This document is intended to illustrate how Regulation No. 6 could be amended to replace the current type approval markings by the Unique Identifier.

Addendum 5: Regulation No. 6

Regulation No. 6

Uniform provisions concerning the approval of direction indicators for power-driven vehicles and their trailers

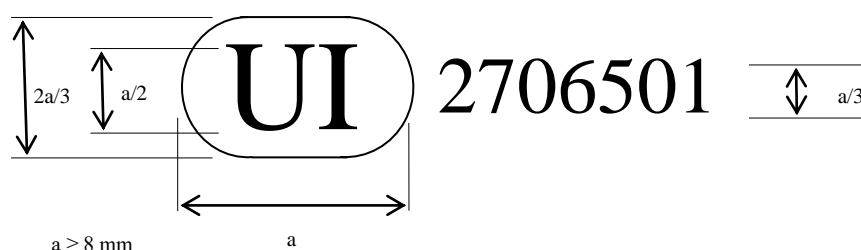
4.1.5. Every device belonging to an approved type shall comprise a space of sufficient size for the Unique Identifier (UI) mark as referred to in Schedule 5 of the 1958 Agreement. This mark shall be clearly legible and indelible and shall follow the format in the example shown below. It may be located on an inner or outer part (transparent or not) of the device which cannot be separated from the transparent part of the device emitting the light. In any case the marking shall be visible when the device is fitted on the vehicle or when a movable part such as the hood or boot lid or a door is opened

The above Unique Identifier marked on the device shows that the type concerned has been approved and that the relevant information on that type approval can be accessed on the UN secure internet database by using 2706501 as the Unique Identifier.
